ADDENDUM NO. 2

Colton MS Pavilion Building Addition

Colton Joint Unified School District
1212 Valencia Drive
Colton, CA 92324

DSA #04-123039

EAST-WEST BUILDING SECTION SCALE: 1/8" = 1'-0" 4

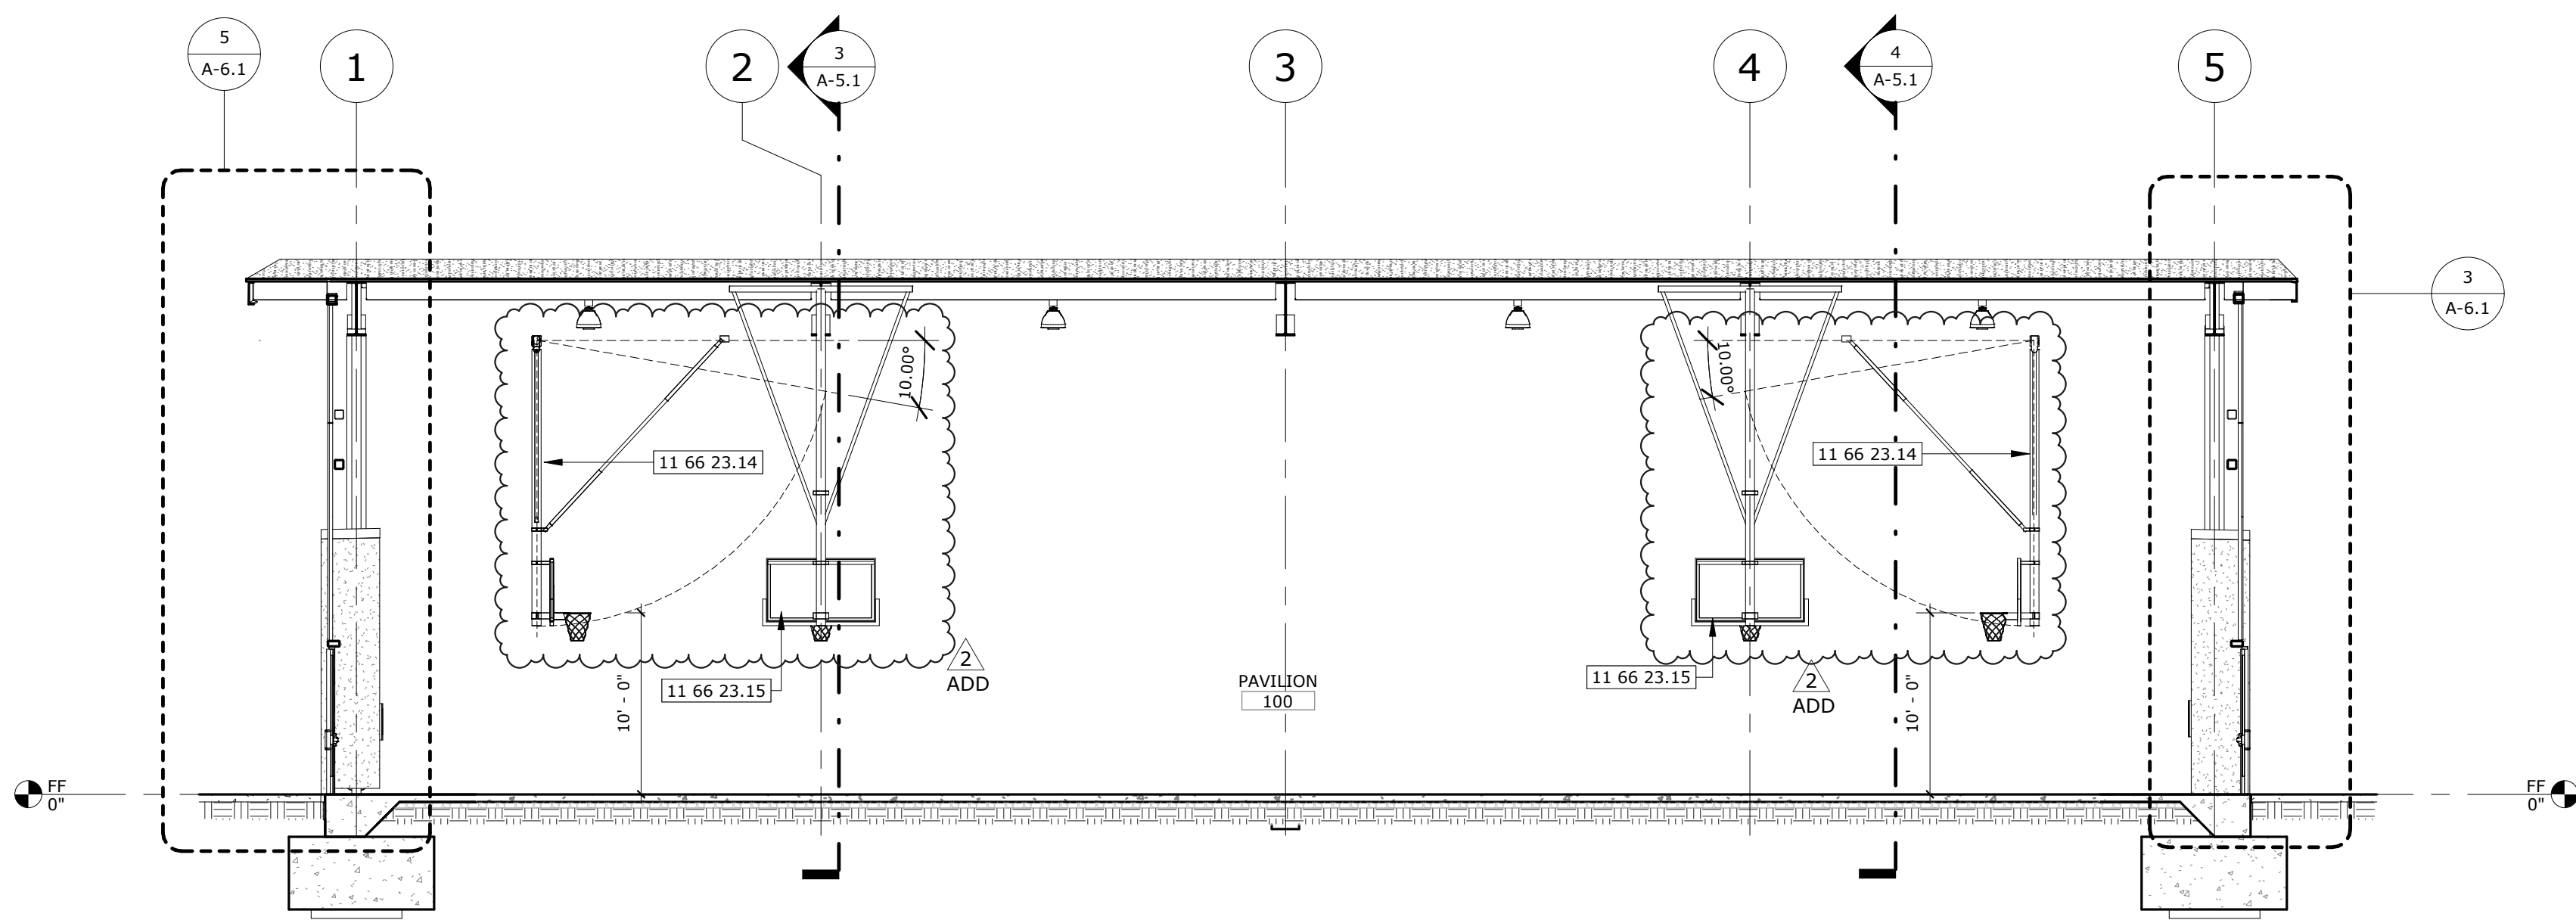
- Item No. 2.7 Reference Sheet A-5.1 – Building Sections:
2.7.1 Revised Keynotes and Details 2 per clouded areas.
- Item No. 2.8 Reference Sheet A-6.1 - Wall Sections:

FOUNDATION PLAN
SCALE: 1/8" = 1'-0"

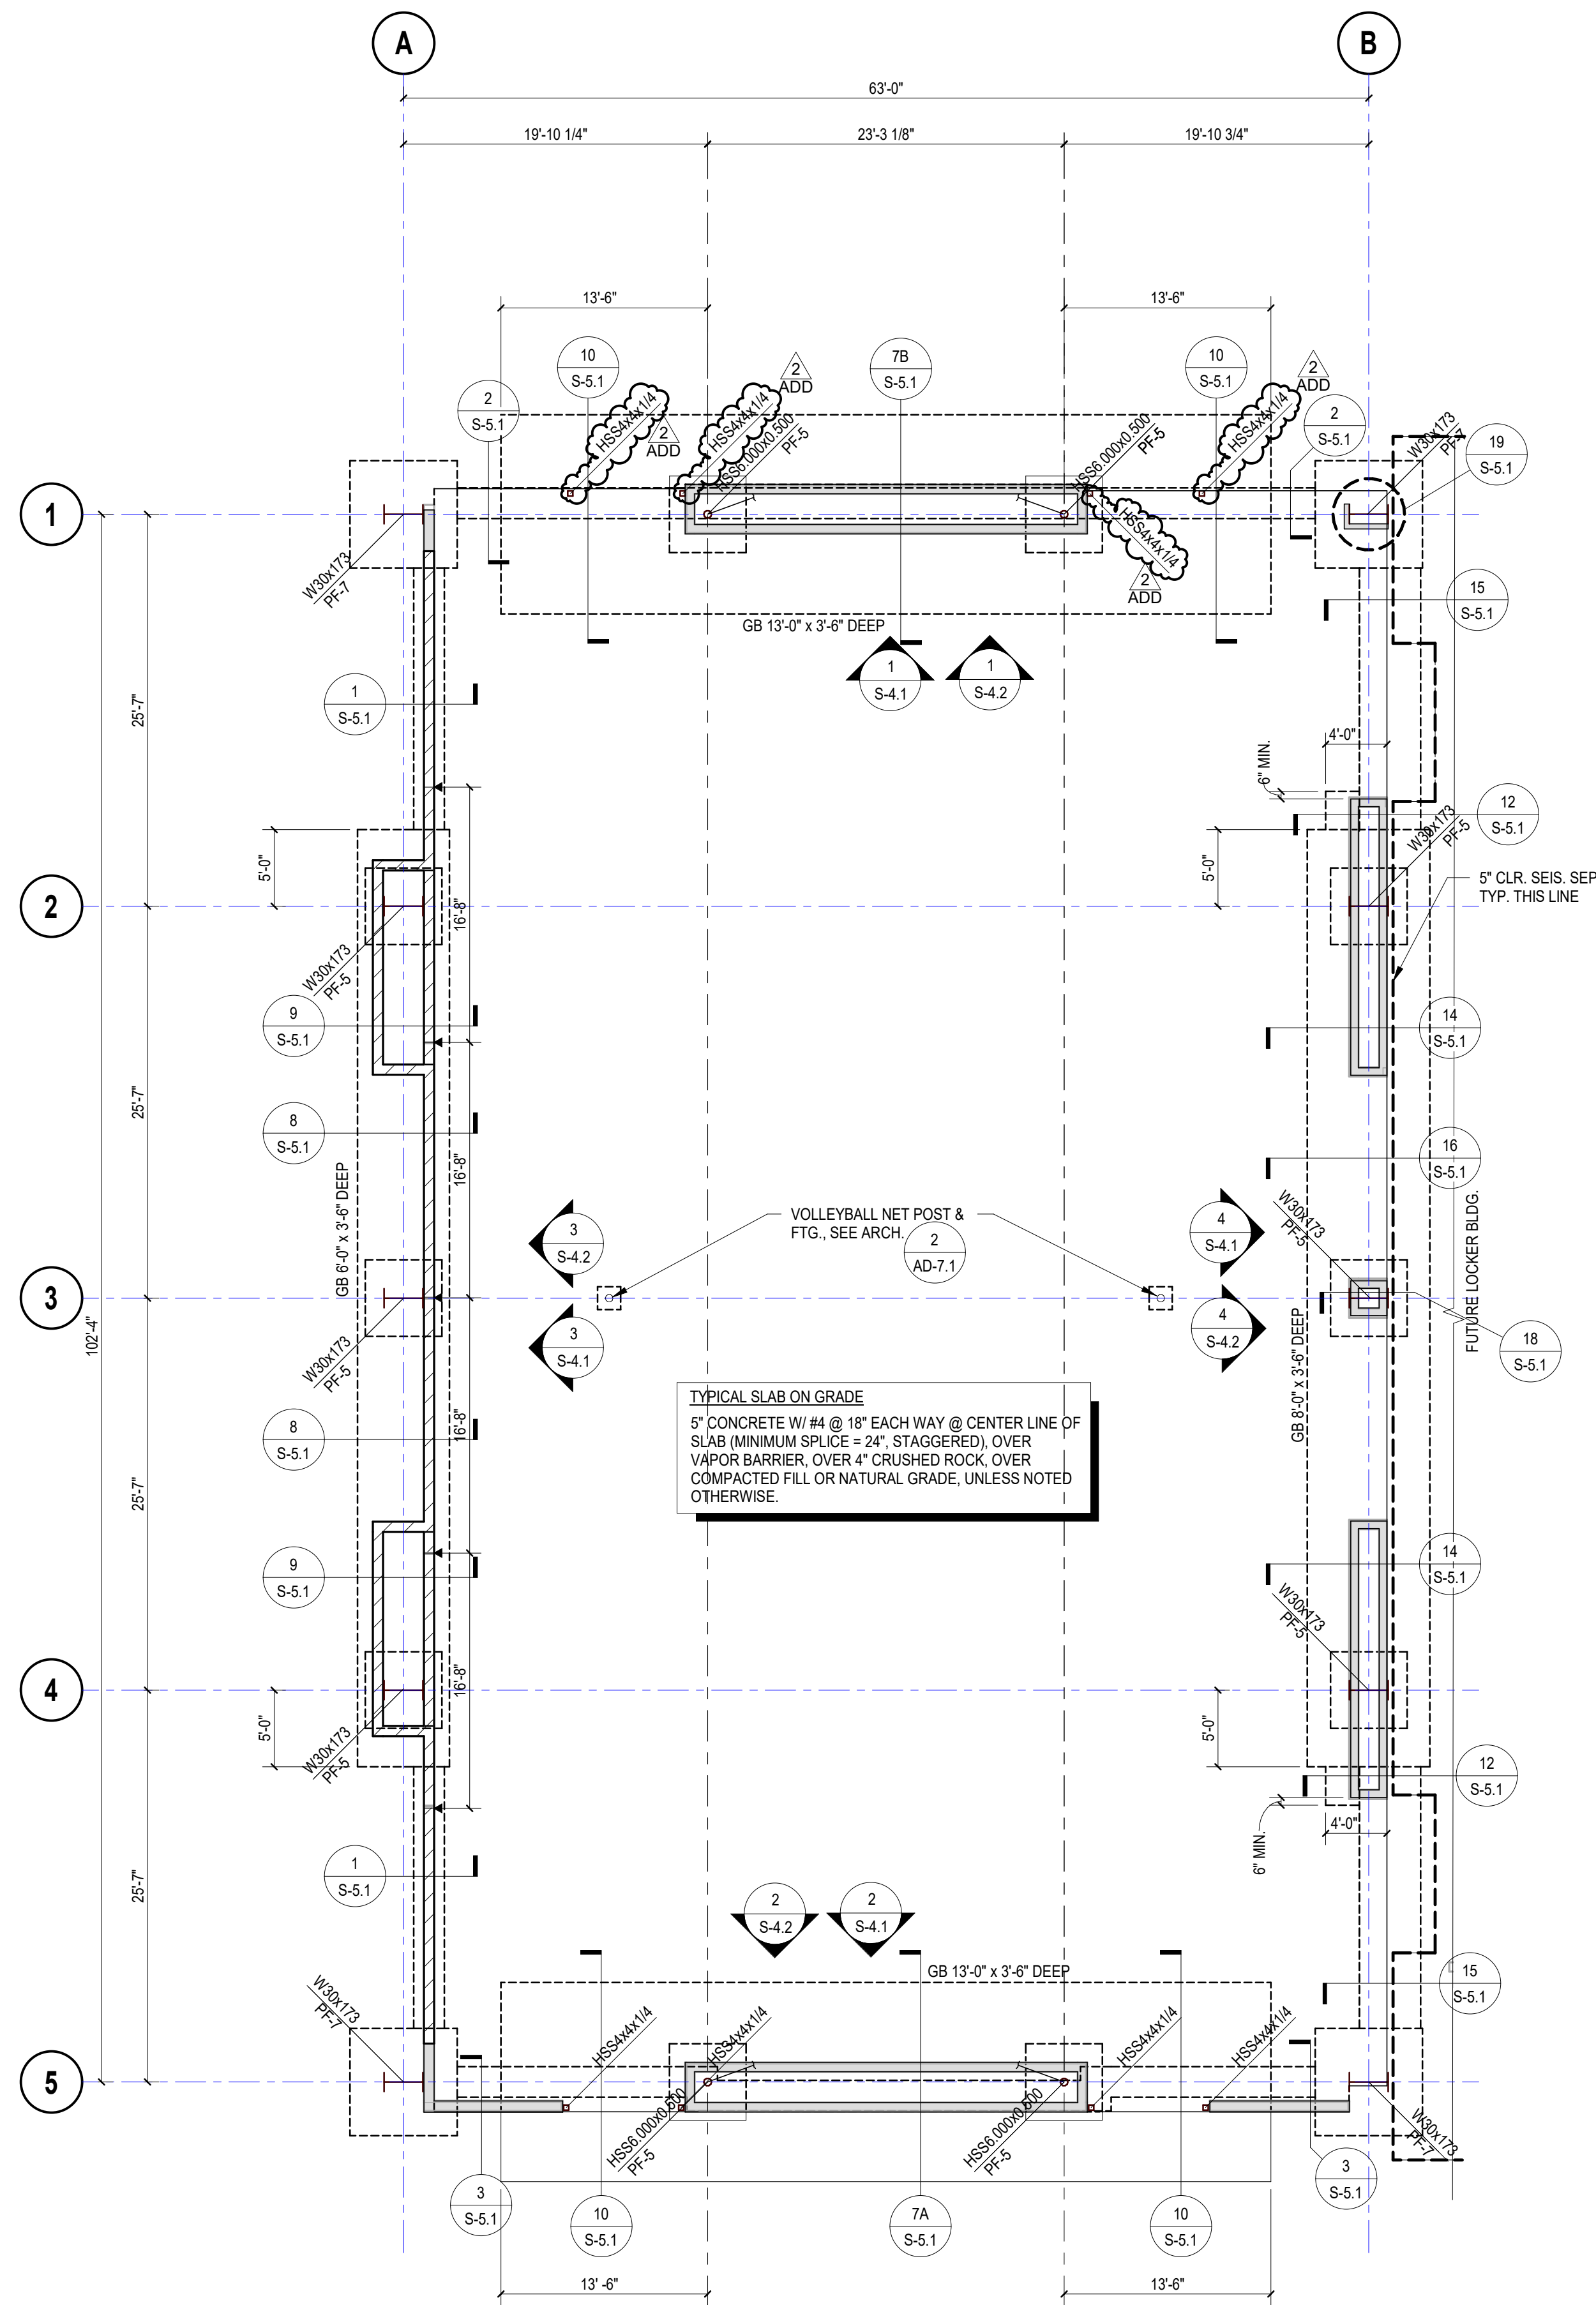
- Item No 2.18 Reference Sheet S-1.1 - Foundation Plan:
2.18.1 Replace Sheet S-1.1 and revise per clouded areas listed below:
a) Shifted HSS door jamb columns to coordinate with updated door locations.
- Item No 2.19 Reference Sheet S-6.1 - Roof Framing Details:
2.19.1 Replace Sheet S-6.1 and revise per clouded areas listed below:
a) Added detail 20 for HSS beam attachment to steel wide flange column web.

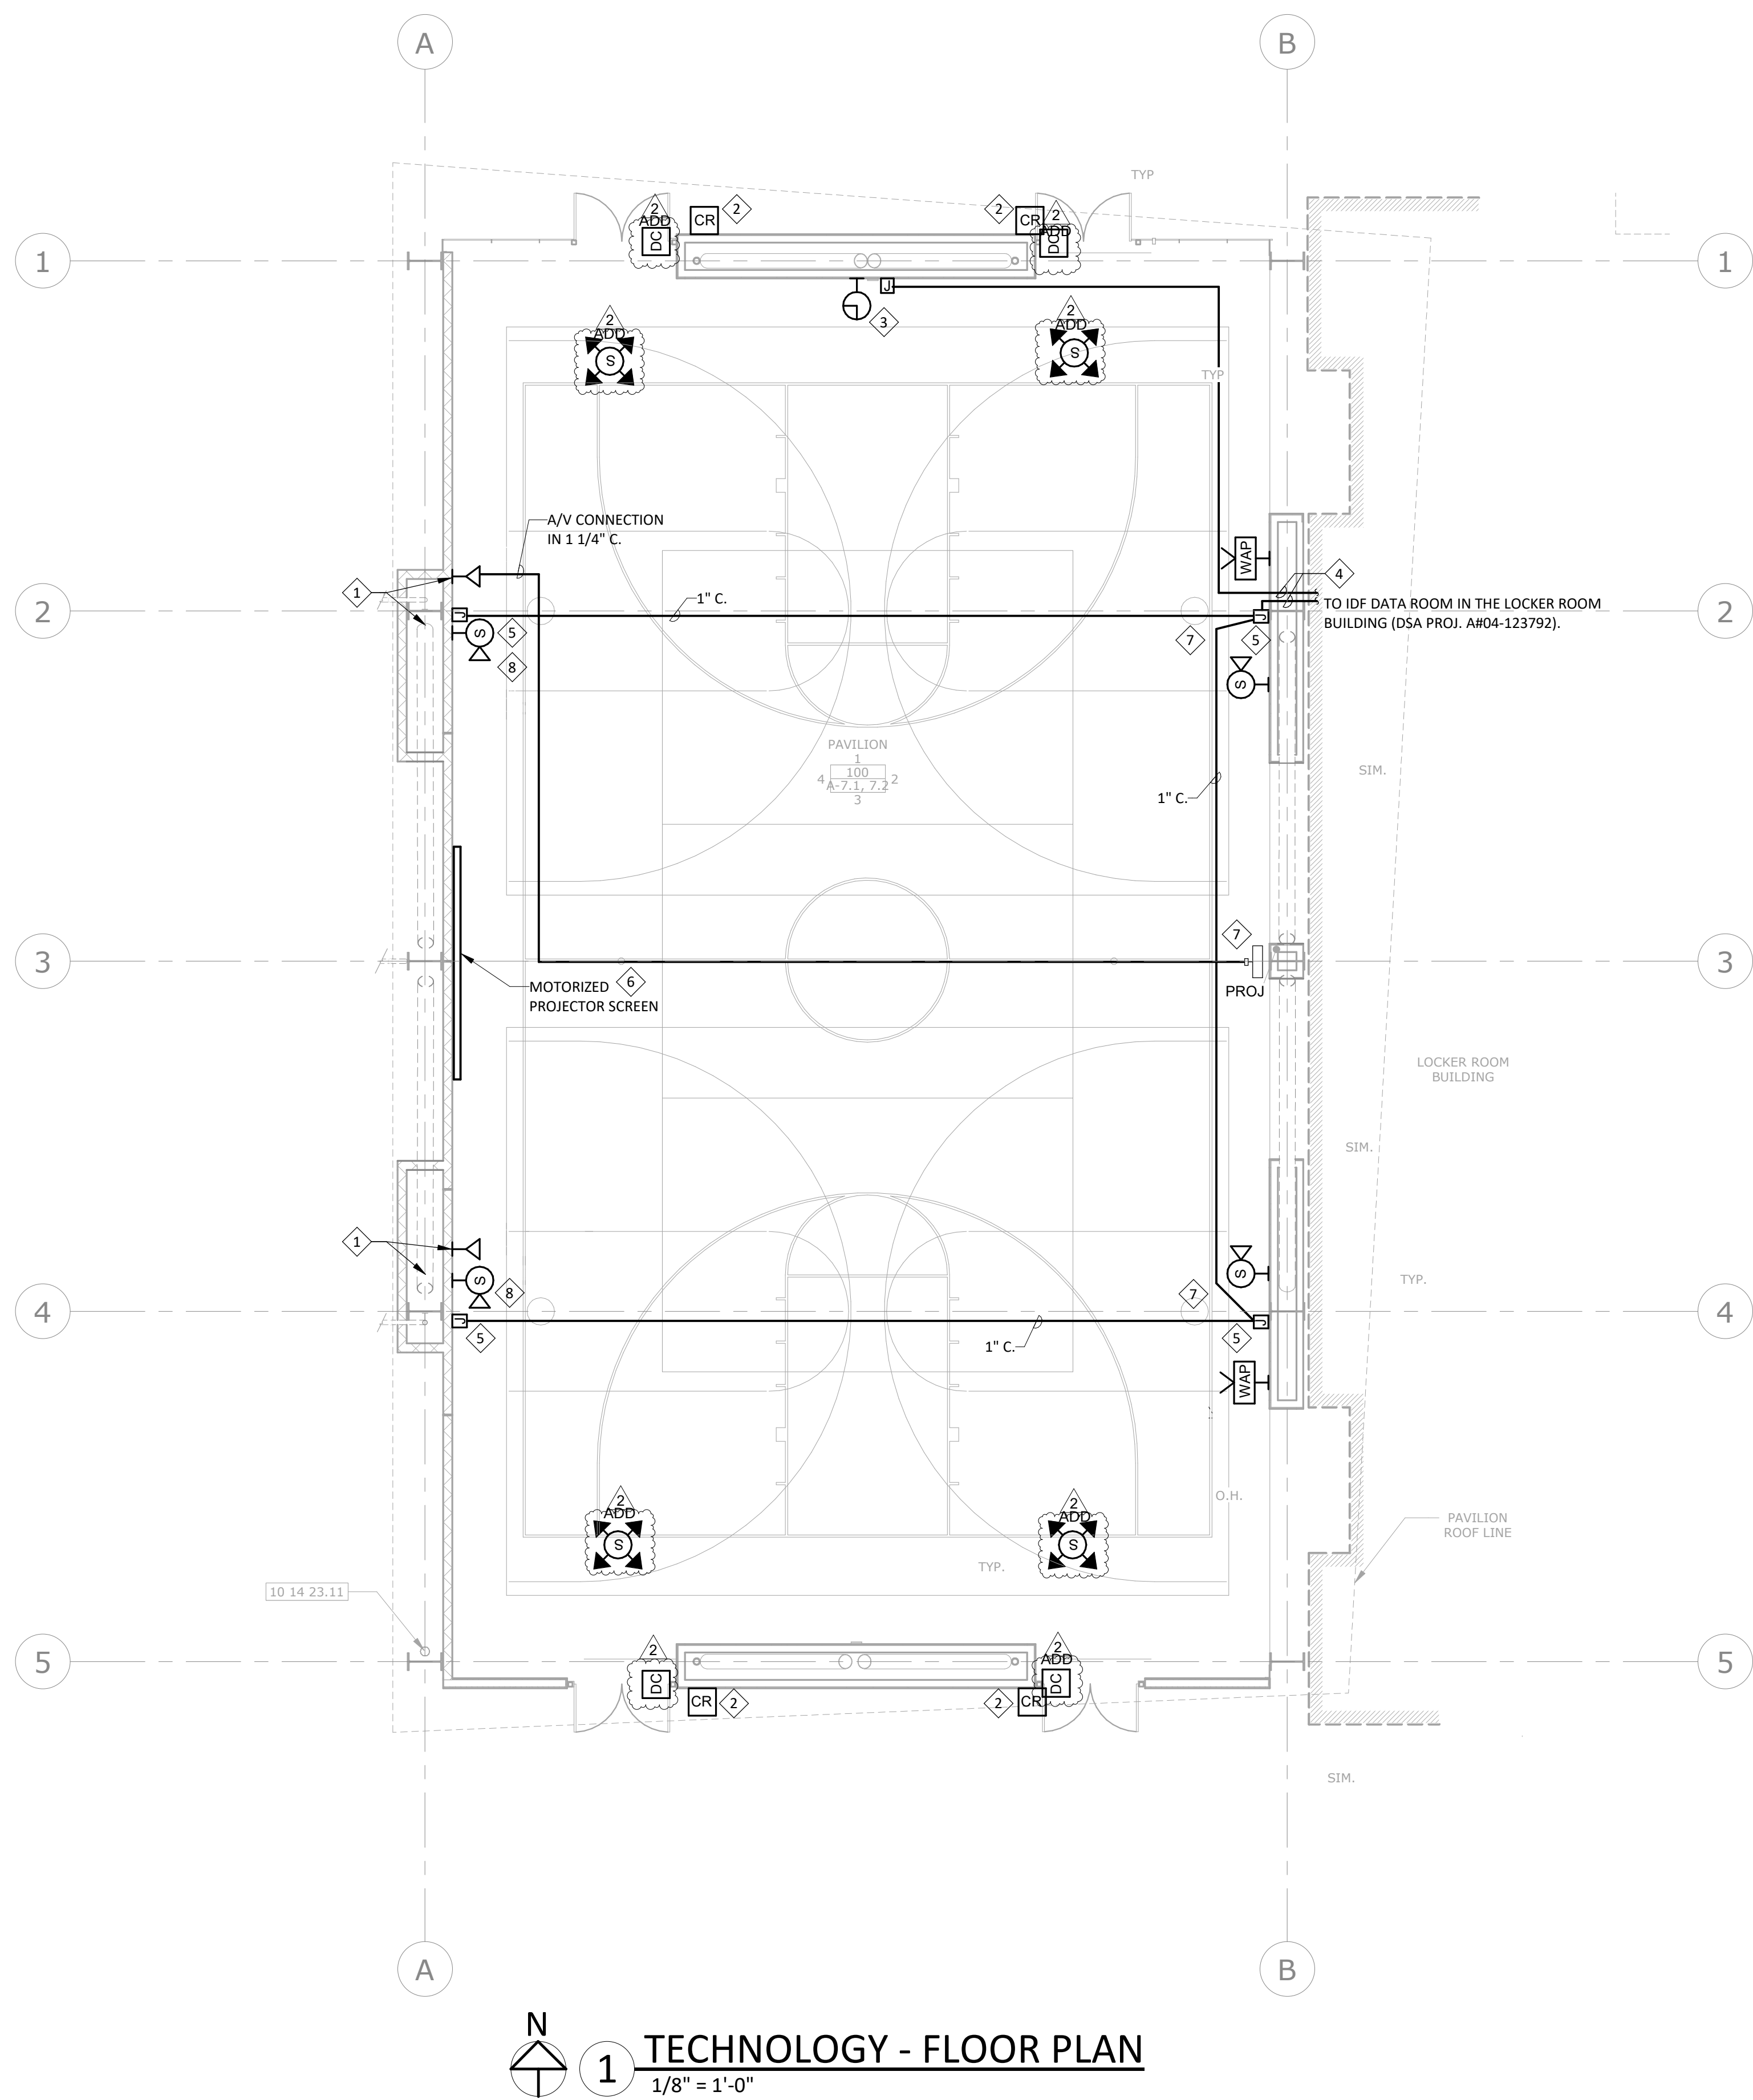
- Item No. 2.21 Reference Sheet T-2.0 – Technology – Floor Plan:
2.21.1 Revise per clouded areas of attached sheet and items listed below
a) Added door contacts at exterior doors.
b) Added motion sensors at exterior doors.
